August 2, 2010

IMPORTANT SAFETY NOTICE CHANGE

To: **All Users of Survivair® Panther™ and Cougar™ Self-Contained Breathing Apparatus (SCBA) Equipped with the Survivair or Sperian COMPASS™ Personal Alert Safety System (PASS)**

Figure 1
Black Four- (4) Point Battery Terminal Connection
COMPASS units with this connection do NOT have to be replaced or have foam inserts installed.

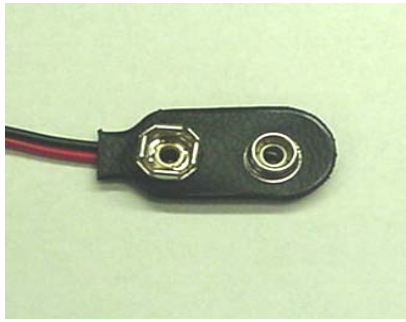
New Course of Action: Spierian Respiratory Protection will provide, under warranty, foam inserts that must be installed, per the accompanying instructions, into the battery compartment of the COMPASS unit. This will prevent the battery terminal connection from losing contact with the battery. Installation may be performed by the end user and does **NOT** have to be performed by a Spierian-certified technician. Installation of the foam insert must be made to any COMPASS that is found to have the black six- (6) point or white six- (6) point battery terminal connection, regardless of age. Installation of the foam insert does **NOT** have to be made to a COMPASS with a black four- (4) point battery terminal connection.
